#### HENDERSON COUNTY PLANNING BOARD

**SUBJECT:** Revised Master and Phase I Development Plan for Laurel Rock Reserve Major

Subdivision (2008-M11)

#### **Henderson County Planning Department Staff Report**

**Map A: CCP Future Land Use Map**

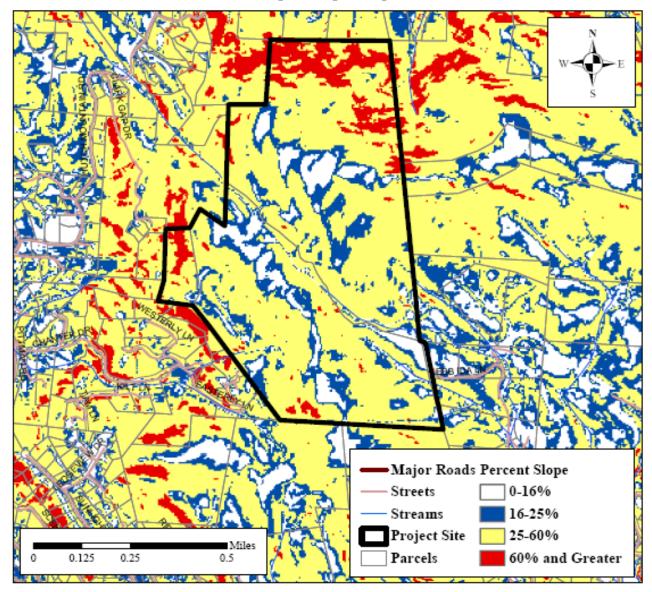
- 1. **Henderson County 2020 Comprehensive Plan (CCP).** The Future Land Use Map of the CCP shows the project site as being located within each of the following areas: Conservation Area and Rural/Agricultural Area (RAA) (See Map A: CCP Future Land Use Map).

- (a) Conservation Area. The conservation area designation is applied to a majority of the project site, largely due to slope and a protected mountain ridge (See Map A: CCP Future Land Use Map, Map B: Slopes Map, and Map C: Protected Ridges). Slopes within the project site appear to be in excess of 25 percent, with portions having slopes in excess of 60 percent. According to the plan, a majority of the steep slope areas within the project site appear to be located in designated common area/open space and are not currently proposed to contain single-family development. The CCP states that conservation lands "are intended to remain largely in their natural state, with only limited development," and further that "such areas should be targeted for protection through regulations and incentives" (2020 CCP, Pg. 134). Under the currently approved Master Plan, 26 lots contain slopes in excess of 60 percent with a condition that where possible, the Applicant shall reconfigure lots and alter the design of the development so that slopes in excess of 60 percent remain in common area/open space. Proposed lots which now contain slopes in excess of 60 percent include the following 20 lots: 17, 23, 32, 70, 71, 91, 99-101, 119, 123-126, 129-134 (See Attachment 8, Revised Master Plan).

Planning Staff and the TRC recommend, as conditions of approval, that: (1) where possible, the Applicant reconfigure lots and alter the design of the development so that slopes in excess of 60 percent remain in common area/open space; and (2) where development plans are approved with lots that contain these slopes that the reason for such lot approval be noted.

**Map C: Protected Ridges Map**

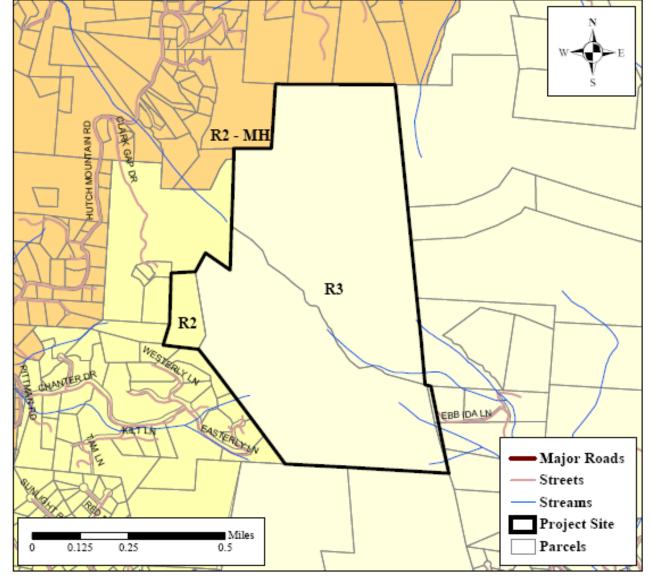
- 2. **Protected Mountain Ridges**. The project site appears to contain areas effected by the Mountain Ridge Protection Ordinance which states that the provisions of NCGS 113A-209 apply to all mountain ridges in Henderson County whose elevation is 500 feet or more above

the adjacent valley floor (Map C: Protected Mountain Ridges). NCGS 113A-209 states that no county may authorize the construction of, and no person may construct, a tall building or structure on any protected mountain ridge. The definition of a tall building found in NCGS 113A-206 is any building with a vertical height of more than 40 feet measured from the top of the foundation and the uppermost point of the building. Additionally, where such foundation measured from the natural finished grade of the crest or the natural finished grade of the high side slope of a ridge exceeds three (3) feet, then such measurement in excess of three (3) feet shall be included in the 40-foot limitation provided that no such building protrudes at its uppermost point above the crest of the ridge by more than 35 feet. The area of ridge under protection is defined as the elongated crest or series of crests at the apex or uppermost point of intersection between two (2) opposite slopes or sides of a mountain, and includes all land 100 feet below the elevation of any portion of such line or surface along the crest. Planning Staff and the TRC recommend, as a condition of approval, that the Applicant shall adhere to the Mountain Ridge Protection regulations of the County which state that the provisions of NCGS 113A-209 apply to all mountain ridges whose elevation is 500 feet or more above the adjacent valley floor.

Branch Turnaround Not To Scale

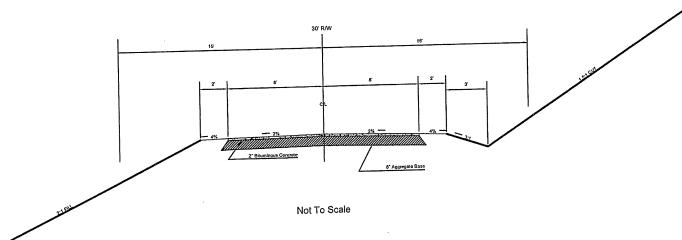
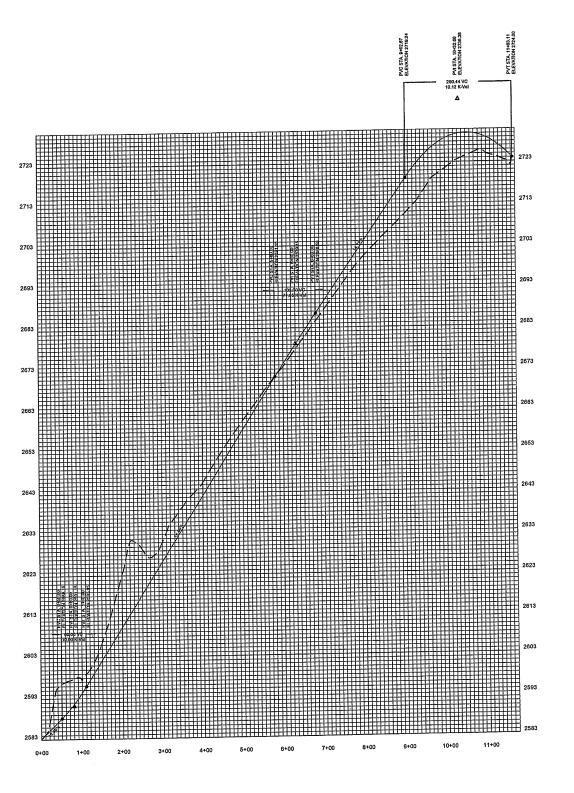
- g. **Dead Ends, Cul-de-sacs and Turnarounds.** The Applicant has proposed branch turnarounds at the end of Braden Lane, Shady Rise Lane, and Broad Bluff Way; and a cul-de-sac at the end of Couch Mountain Drive. The cross sections shown on Development Plan Sheet RT2 (Attachment 9) appear to meet the requirements of LDC §200A-81 C(8). No turn around is required at the end of Youngblood Way as

the road is less than 300 feet in length. The reviewing agency may require additional turnarounds at intermediate locations along dead end roads with a centerline length of greater than 2,500 feet (LDC §200A-81 C(8). Couch Mountain Drive is approximately 2,800 feet in length and does not provide an alternative turnaround. The Planning Board may require, as a condition of approval, that the Applicant provide an alternative turnaround at an appropriate location along the proposed road.
